BCA ASSESSMENT REPORT

DUKE of KENT HOUSING PROJECT

**18-22 SPRING STREET & 21-25 NORTH PARADE,
WAGGA WAGGA**

14 September 2022

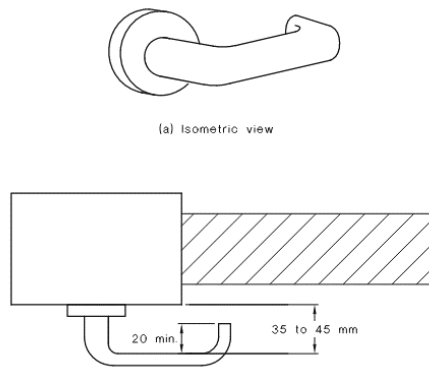
The following highlighted external walls in blue indicates the approximate extent of the buildings exposed and located within 18m of a fire source feature (FSF ie. side allotment boundary or adjacent building).

4.7 Installation in Exits and Paths of Travel (BCA Clause D2.7)

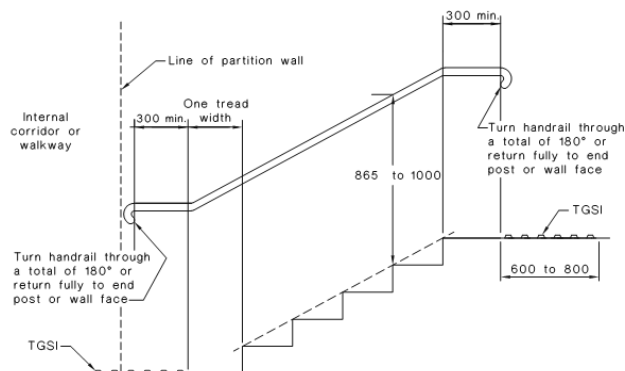
If services or equipment comprising electricity meters, distribution boards, central telecommunications distribution boards or equipment and the like are installed in a public corridor or lobby leading to a required exit they must be enclosed by non-combustible construction or a fire-protective covering with doorways or openings suitably sealed against smoke spreading from the enclosure. To be detailed applicable where applicable.

Exit Level G
DOOR ENTRY #

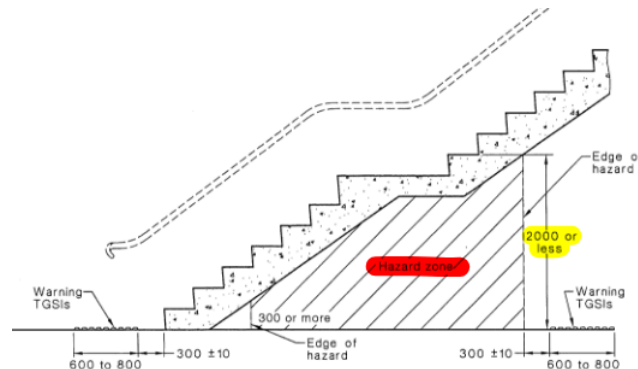
Tactile indicators are to be detailed to the side and under stairways in accordance with AS1428.4-2009 if it is proposed to be open under the stairways creating an overhead obstruction less than 2m.

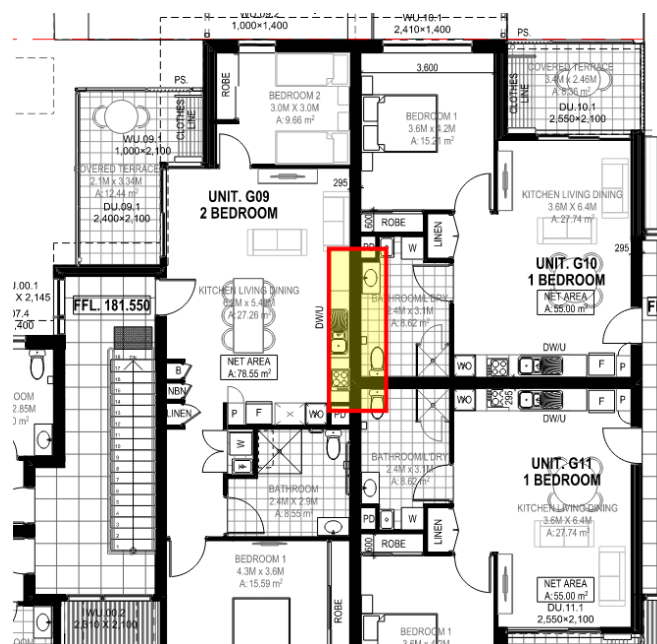
Discontinuous construction to be detailed for areas such as below in the North Parade building.

(Ground level 1 similar)
